PCN	Product Change Notification	De-22-09-0627	
Product	M8/M12	Date of Publication:	
		02.09.2022

**Title:** M12 Circular Connector new shielding component

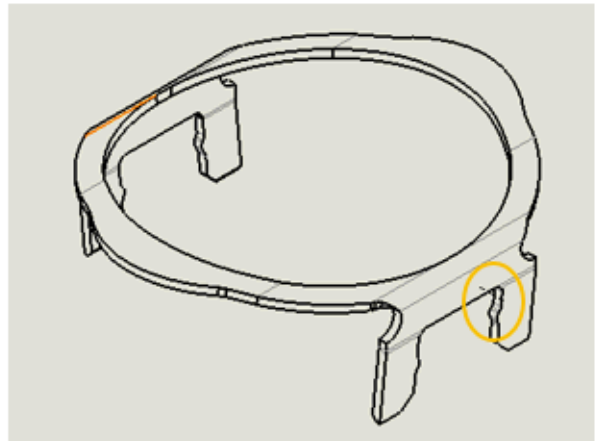
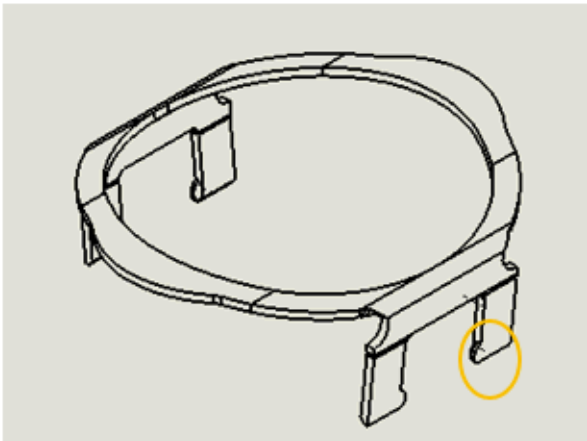
Valued customer,  
in order to optimize our assembly processes, we introduce a new shielding component. The difference between the old and the new part is the fixation geometry, that keeps the shielding component on the connector until the solder clips are assembled.

This change will be operated without partnumber change of the connector and has no impact on form fit or function of the connector.
